# DISCRETIONARY REVIEW ABBREVIATED ANALYSIS

**HEARING DATE: April 29, 2021**

**Record No.:** 2021-000389DRP  
**Project Address:** 366-368 Collingwood Street  
**Permit Applications:** 2020.1120.9381  
**Zoning:** RH-2 [Residential-House, Two Family]  
40-X Height and Bulk District  
**Block/Lot:** 2751/ 036, 037  
**Project Sponsor:** Jamie Maestro  
101 Broadway #309  
Oakland, CA 94607  
**Staff Contact:** David Winslow – (628) 652-7335  
[david.winslow@sfgov.org](mailto:david.winslow@sfgov.org)

The project proposes to expand the roof decks at two upper units of the three-family home.

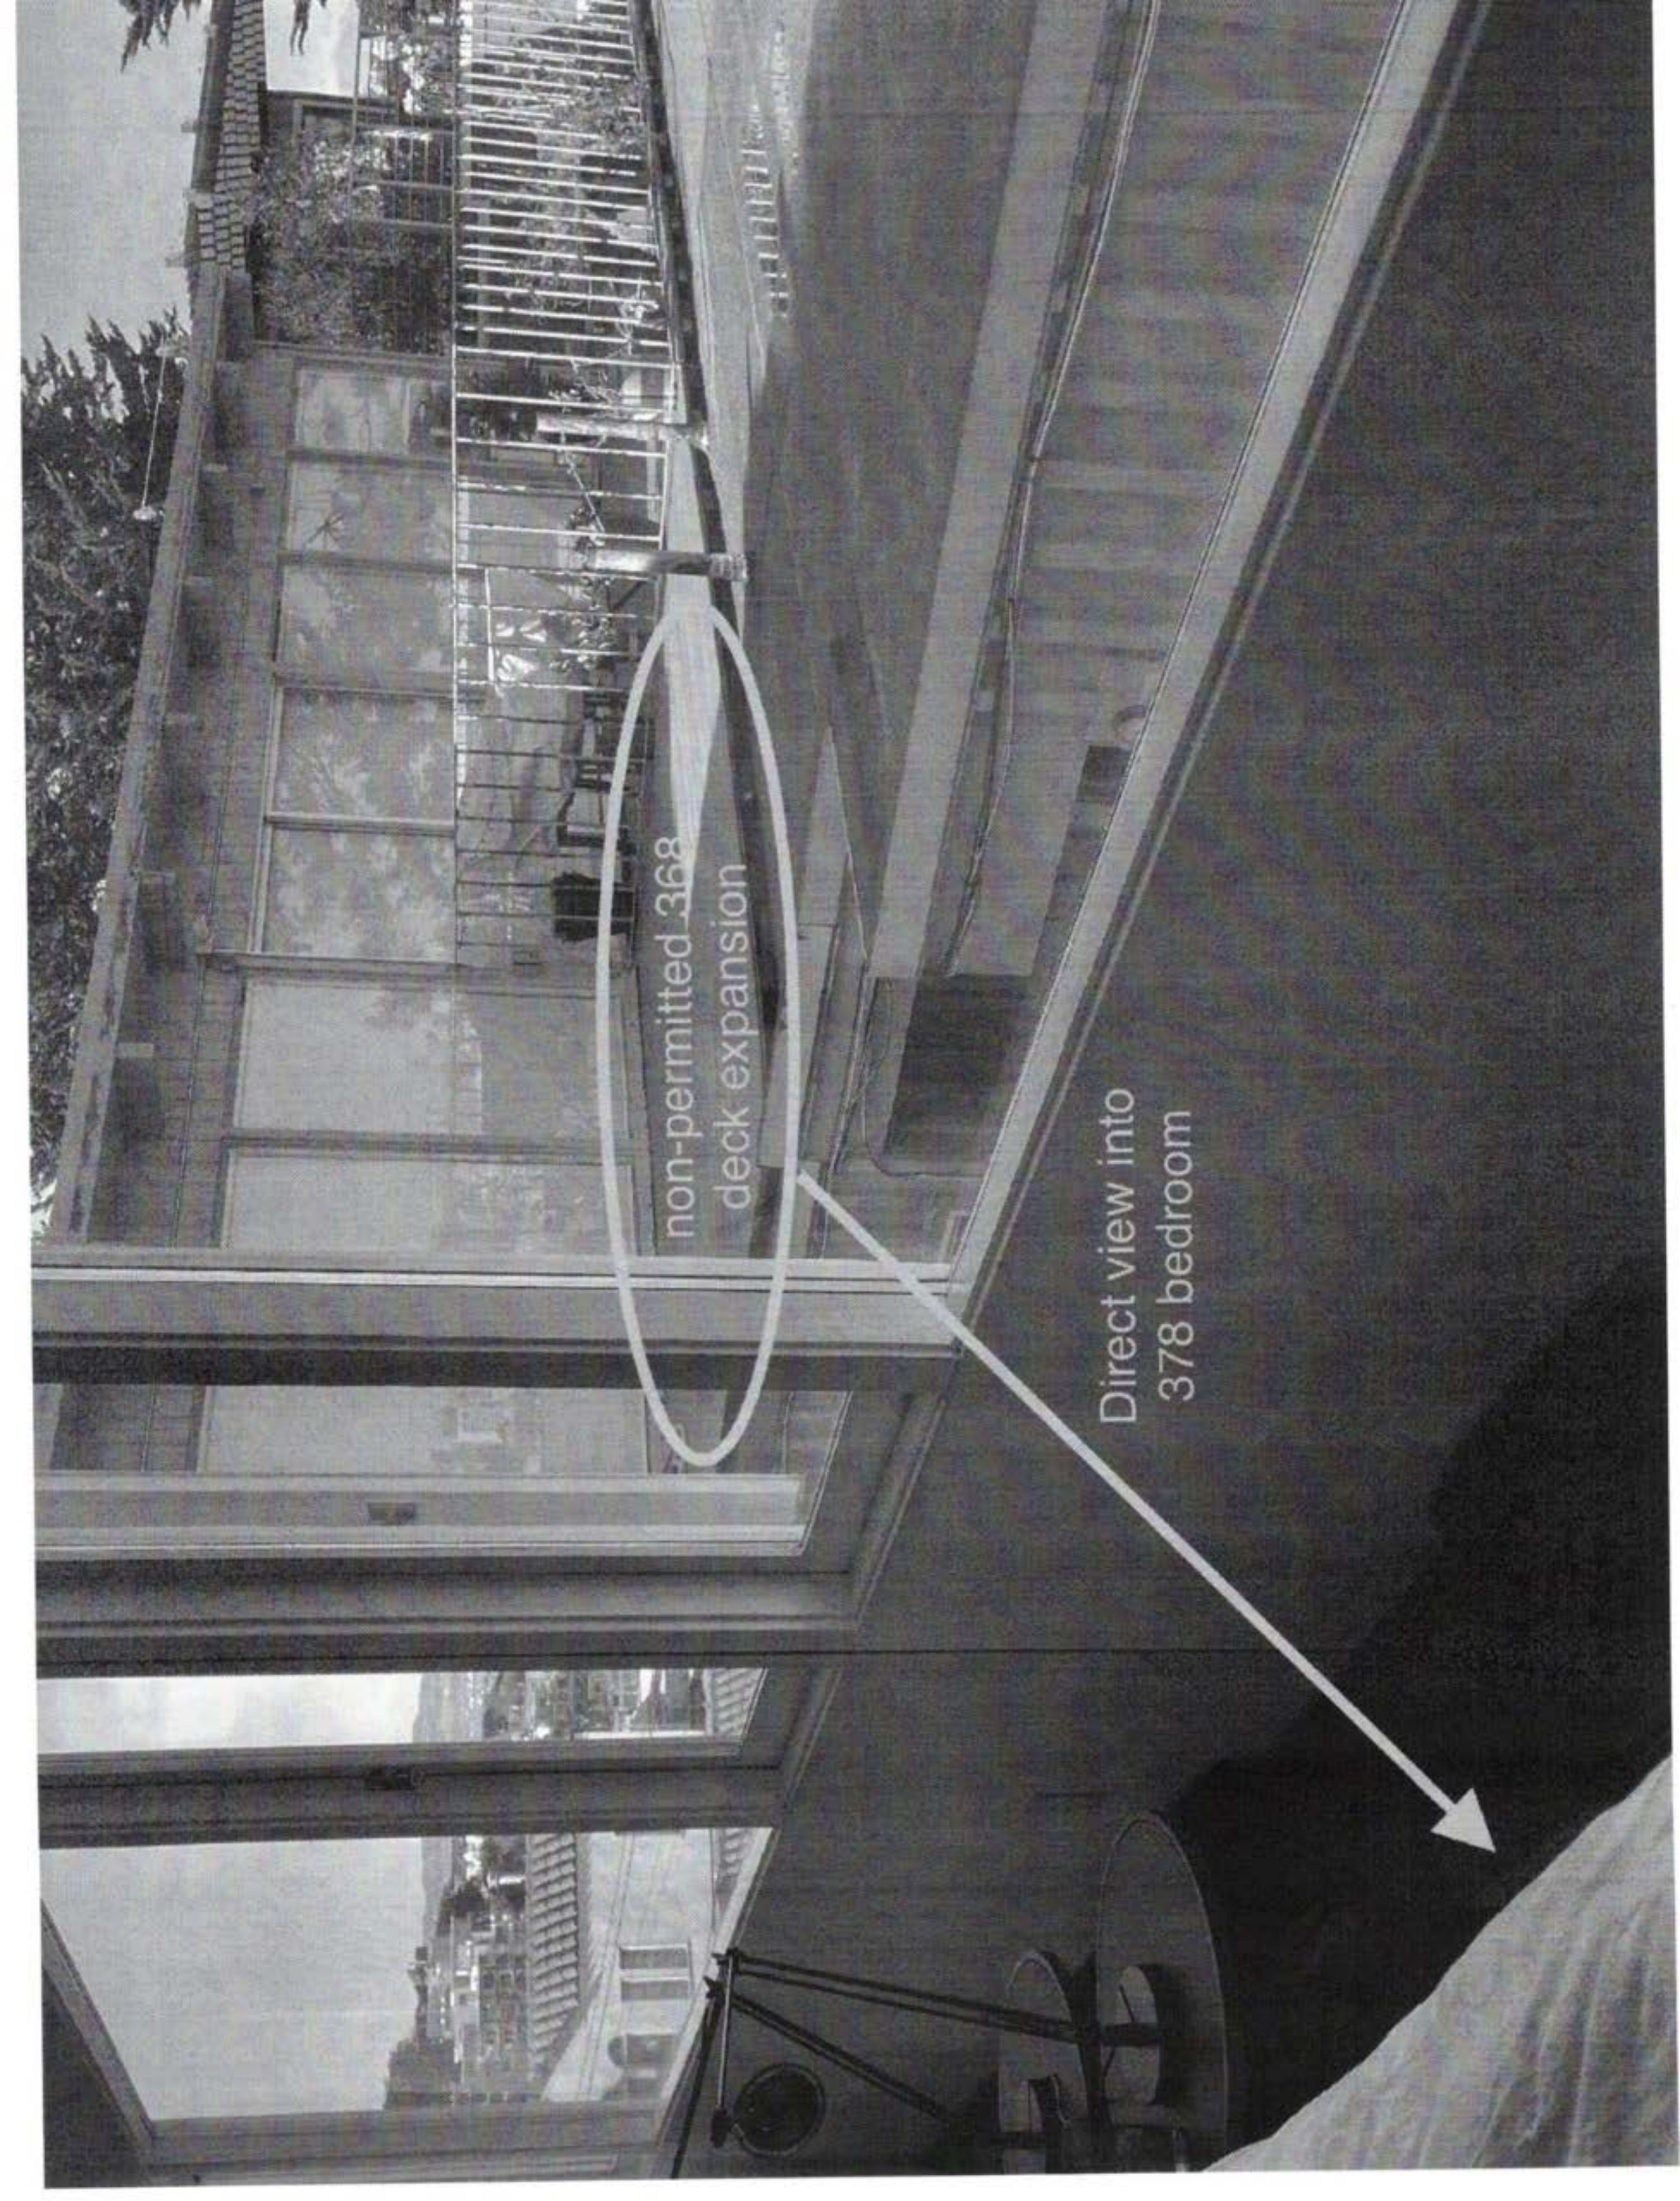
non-permitted 368  
deck expansion

Direct view into  
378 bedroom

366 C.

Downstairs bedroom  
windows

Propose deck  
expansion

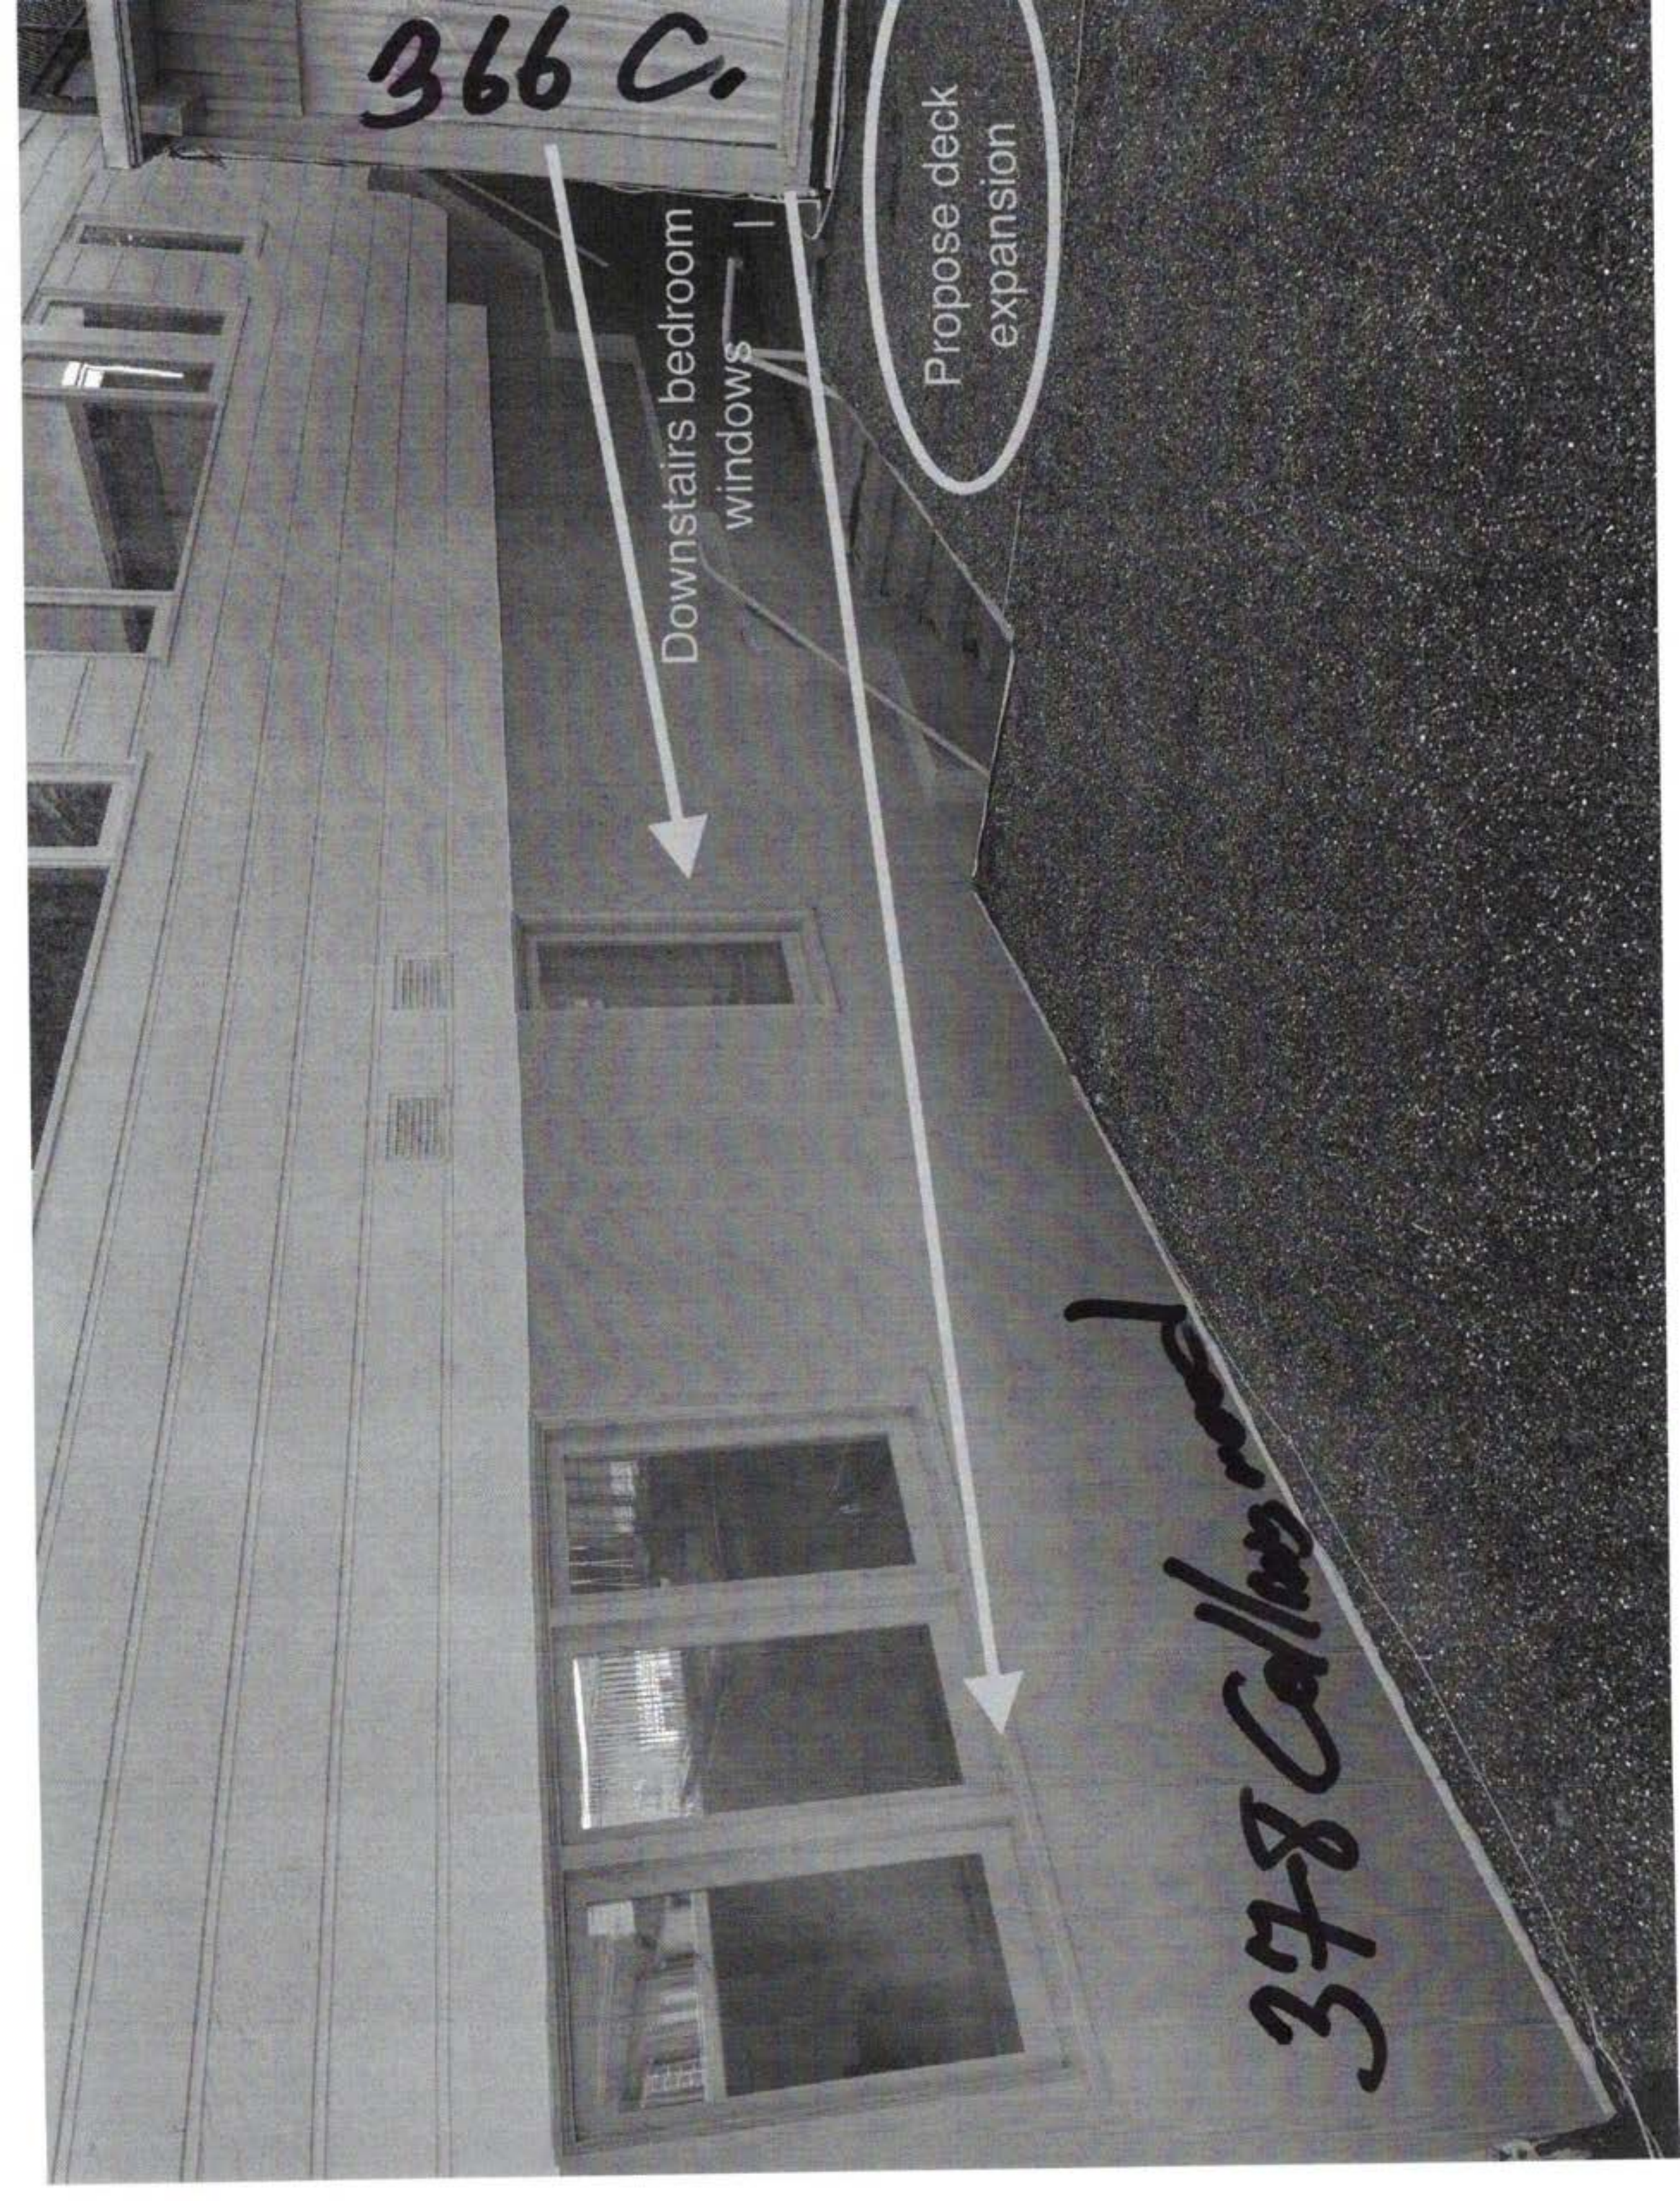
378 Callow road

368 Collingwood  
deck

non-permitted  
expansion

View into  
bathroom

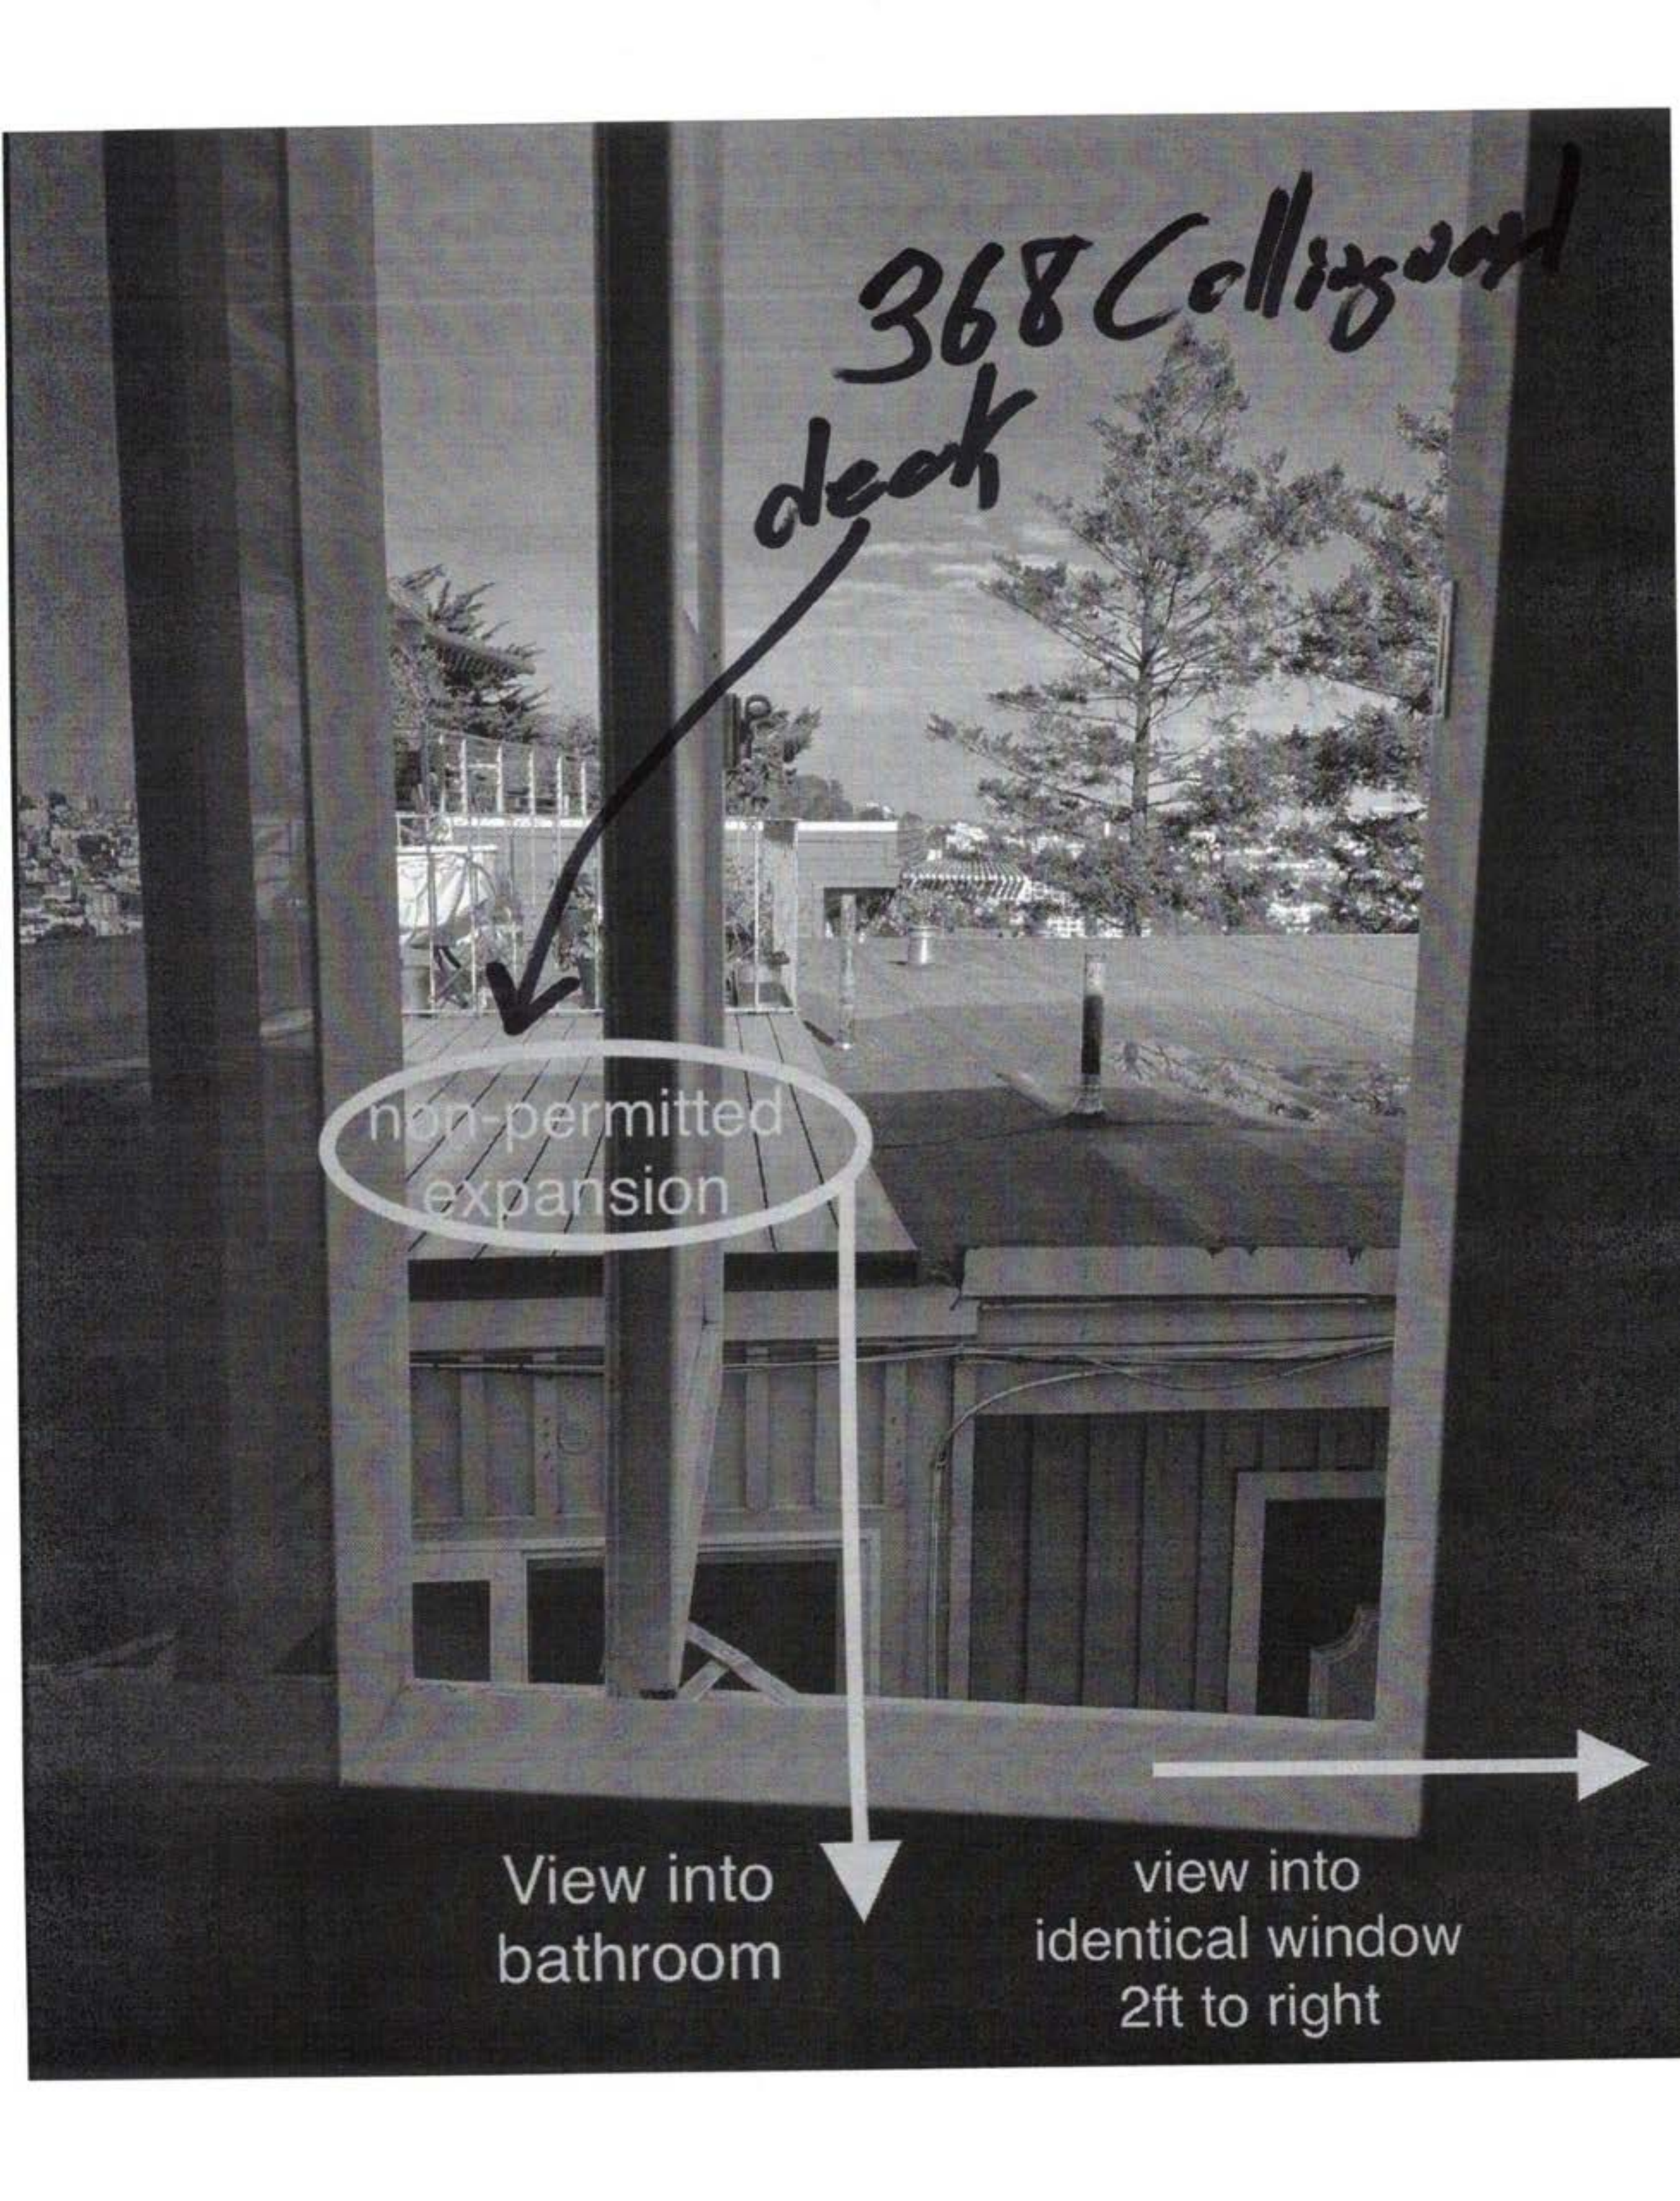
view into  
identical window  
2ft to right
